# 1 and 2 Cumberland Place, London, NW1 4NA (2026/2361/P and 2026/2436/L)

SITE PHOTOS, PLANS AND SUPPORTING DOCUMENTS

| <b>Delegated Report</b><br><b>(Members Briefing)</b>                                                                                                                                                                                                                                                                                                                                                                                                                                                                                                                                                                                                                                              |                            | <b>Analysis sheet</b>                                                                                                           |                                     | <b>Expiry Date:</b>              | <b>04/08/2026</b> |

Figure 6 – Extract from proposed 1<sup>st</sup> floor plan (above) showing new cupboard

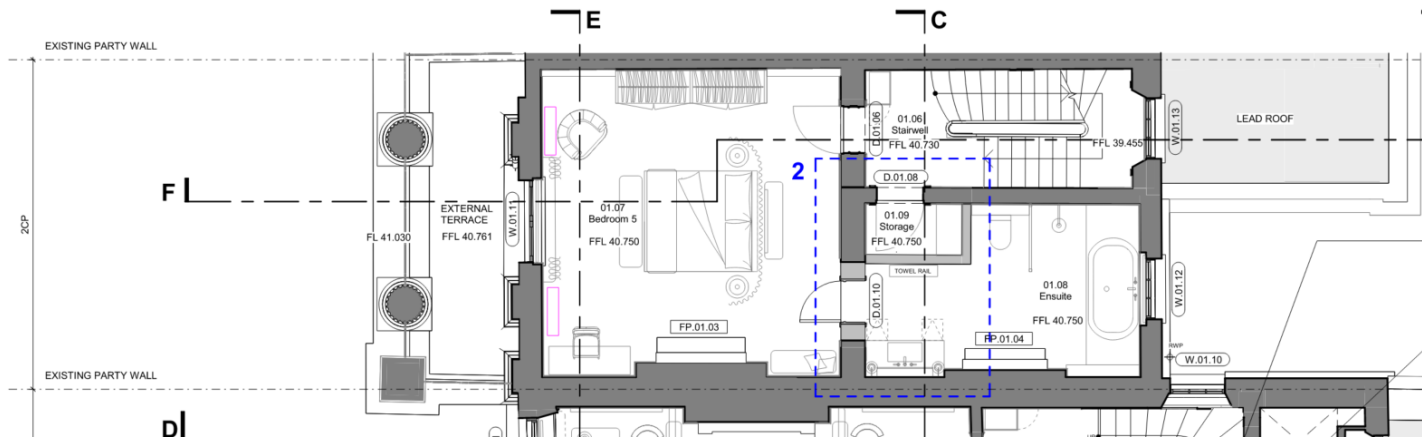
6.11 The CAAC has raised concern regarding the introduction of a cupboard within the rear reception room of no. 2 advising that this would diminish the formal character and plan form of the room. The introduction of built-in furniture in this location is acknowledged to be less desirable in plan-form terms. However, its impact would be limited by requiring the cupboard to be non-full height so that it reads as a pod or item of furniture rather than as a permanent subdivision of the room. This would minimise its effect upon the perception of the overall space and would be secured by condition. The intervention would also be seen in the context of the associated narrowing of the non-historic spine-wall opening and the resulting improvement to the symmetry of the doorways. Taken together, the works at this level would not harm the significance of the listed building.

Figure 8 – Extract from proposed 2<sup>nd</sup> floor plan of no. 2 showing new pod bathroom

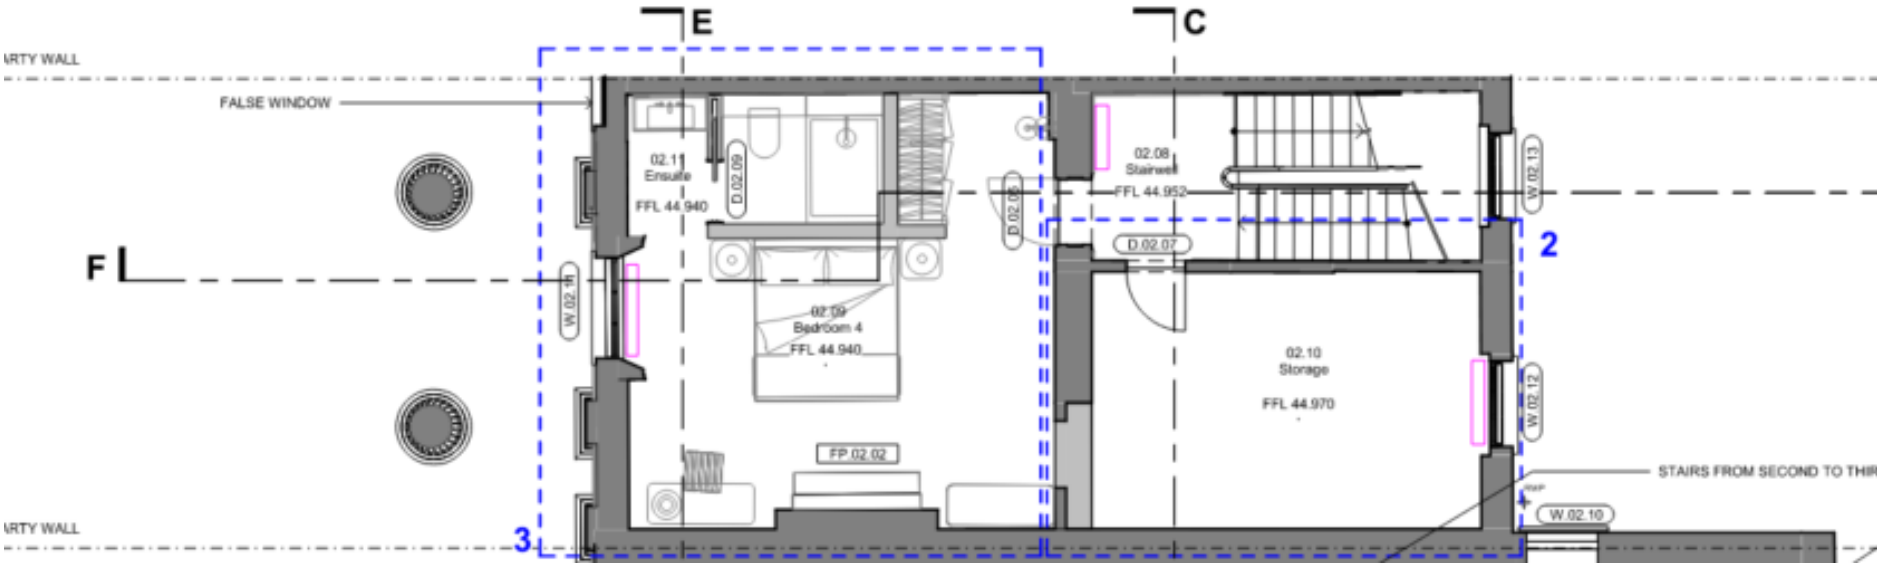
6.13 The CAAC has objected to the insertion of a new en-suite bathroom within the front room principally because of its effect upon the original proportions of the room and its relationship with the historic window. Although the underlying form of the room remains appreciable, this part of the building has undergone previous alterations and contains limited surviving historic fabric. The new en-suite would be required by condition to comprise a non-full-height, non-solid enclosure so that it reads as a reversible insertion rather than a permanent alteration to the historic plan form. This intervention must also be considered alongside the removal of the existing en-suite from the adjoining room and removal of the non-historic spine-wall opening, both of which would improve the legibility of the plan arrangement. On balance, the works at this level are considered acceptable and would preserve the

Figure 1: Extract from proposed lower ground floor plan showing lateral connection between no. 1 and no. 2 (above in red) and photo of location of opening between no. 1 and no. 2 (left)

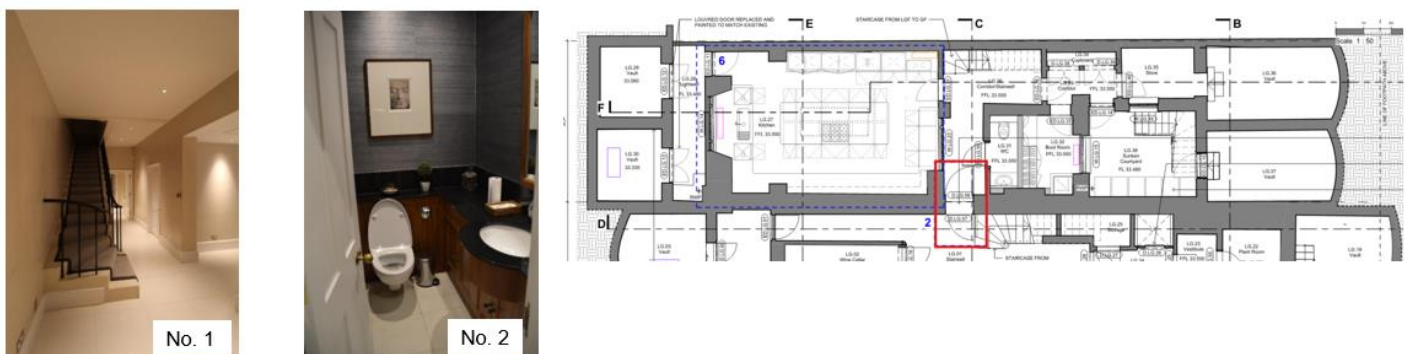
6.6 At lower ground floor level the proposed works would principally affect modern fabric and areas of comparatively low significance. One of the two lateral connections referred to above would be formed at this level. Given its location within a secondary and previously altered part of the buildings, its narrow width and the provision of jib doors on either side, the connection would constitute a discreet intervention and would not materially erode the legibility of the individual houses (see figure 1 above).
